Agenda – Council – June 23, 2022

Item No. 6 Subdivision and Rezoning – 463 and 465 Edison Avenue (North Kildonan Ward) File DASZ 18/2022 [c/r DAV 116752/2022D]

Title: DASZ 18/2022 – 463 & 465 Edison Avenue

Figure 3: Site map showing the existing and proposed buildings relative to the existing properties in the area

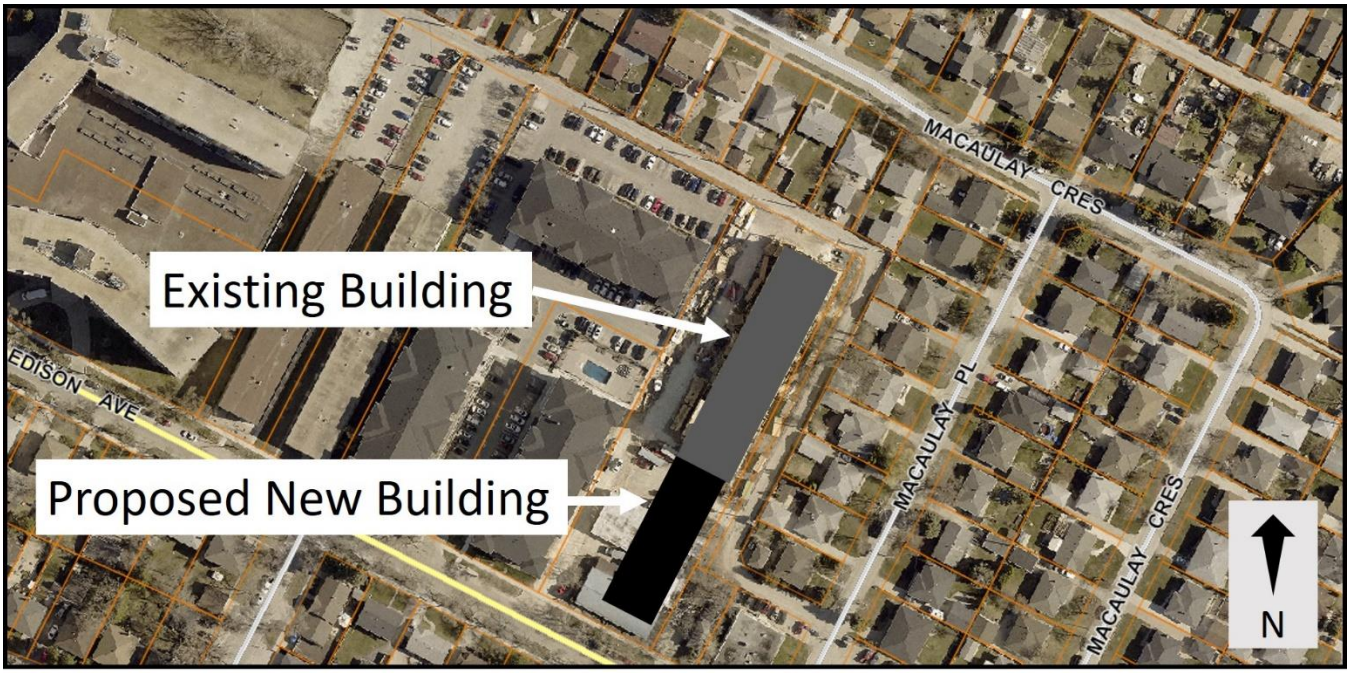
- The current multi-family building on proposed lot 1 is approximately 259’ 7” in length. The proposed second building would extend the total length of the building by approximately 183’ 4”, creating a total building length of approximately 442’ 11” and adding 51 dwelling units to the existing development. This will result in the building being more than half the length of the adjacent block of Macaulay Place (pictured in Figure 3 below), which is almost exclusively single-family dwellings zoned “R1-M” Residential Single-Family (Medium). This is a substantial change to the neighbourhood and is not complimentary to the existing scale, character, and built form of existing buildings

- The proposal would locate an “RMF-L” Residential Multi-Family (Large) zoning district adjacent to an “R1-M” Residential Single-Family (Medium), separated by a public lane and a 12.9 foot wide strip of city owned land. This locates the highest density multi-family residential zoning district next to a single-family residential zoning district with minimal separation space or buffering in between, and therefore does not provide an adequate transition between new and existing developments
